Docket Number:	82-AFC-01C
Project Title:	Compliance - Application for Certification for PG&E Geysers Unit 20
TN #:	207102
Document Title:	Geysers Power â€™ Grant (Unit 20) Cooling Tower Replacement Project Description and Request for Expedited Processing
Description:	N/A
Filer:	Camile Remy-Obad
Organization:	Geysers Power Company, LLC
Submitter Role:	Public
Submission Date:	12/22/2015 3:00:21 PM
Docketed Date:	12/22/2015

RE: Geysers Power Company Grant (Unit 20) Geothermal Project (82-AFC-01C):
Request for Expedited Processing Pursuant to Executive Order B-36-15

**Cooling Tower Replacement
Project Description**

THE GEYSERS		SONOMA/LAKE COUNTIES	
TITLE:			
The Geysers Project			
Grant PP (Unit-20)			
(Cooling Tower Staging)			
SCALE	SHEET NO.	SHEET	OF

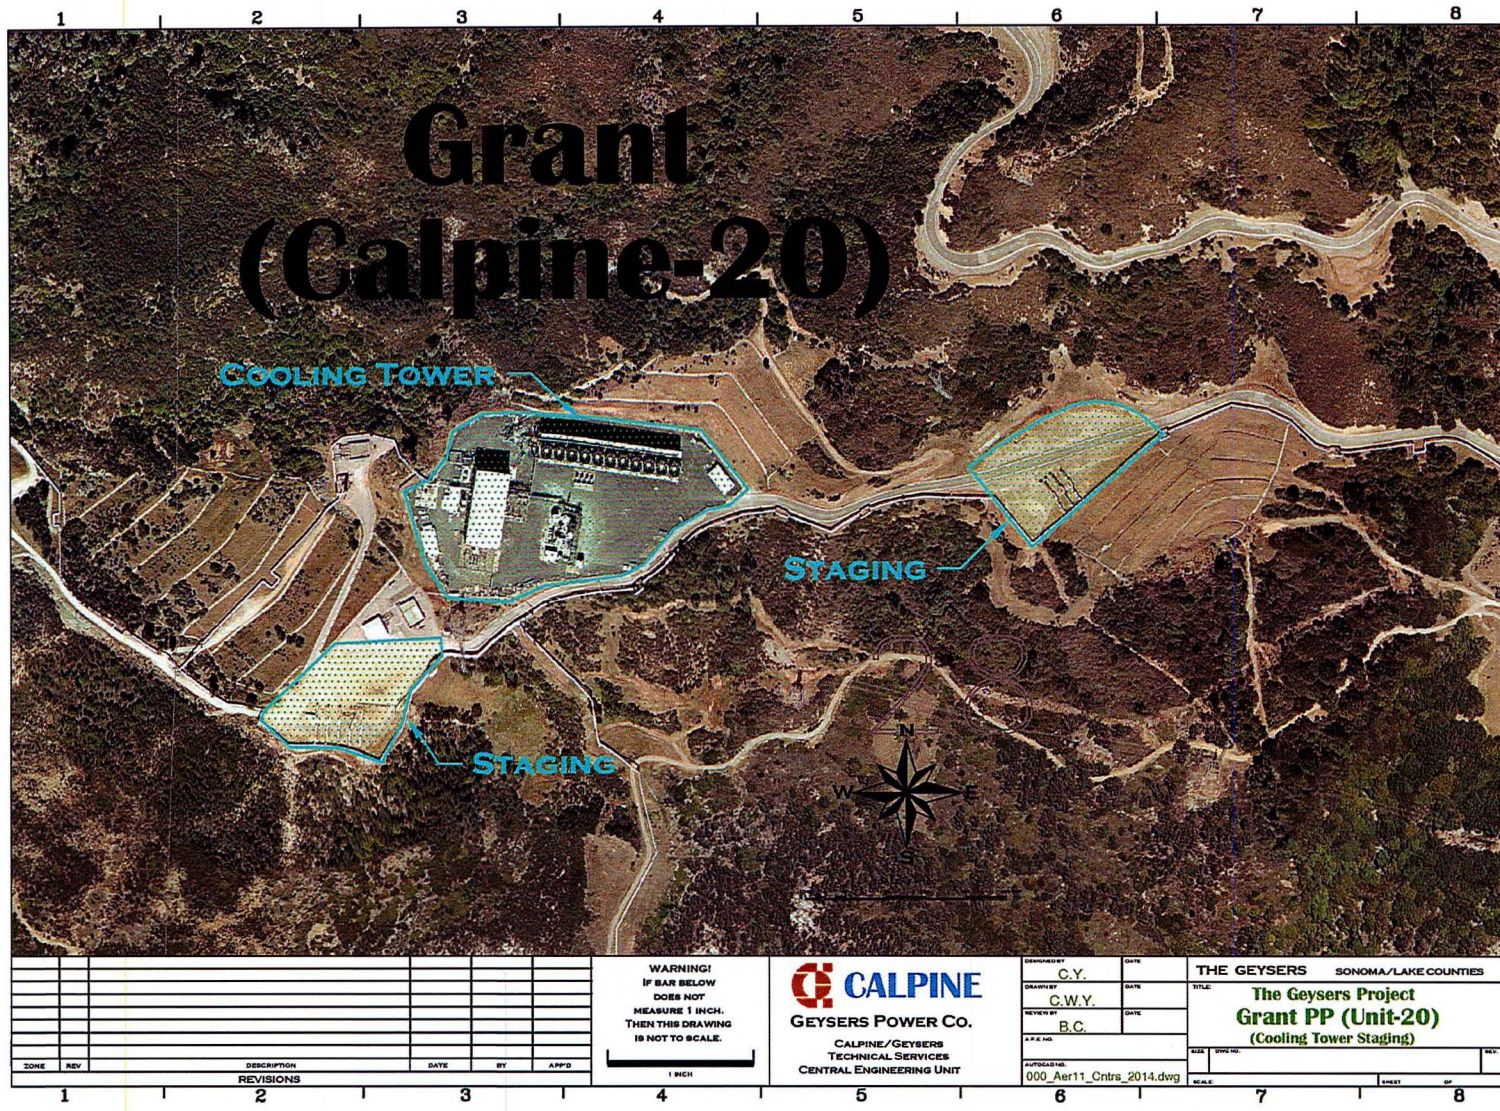
Reconstruction of the towers will take approximately five months and the number of workers will be an average of 30 and a predicted maximum of 55. There will be on-site security during the operation. Potable water, hygiene facilities and refuse containers will be provided to accommodate the number of workers.
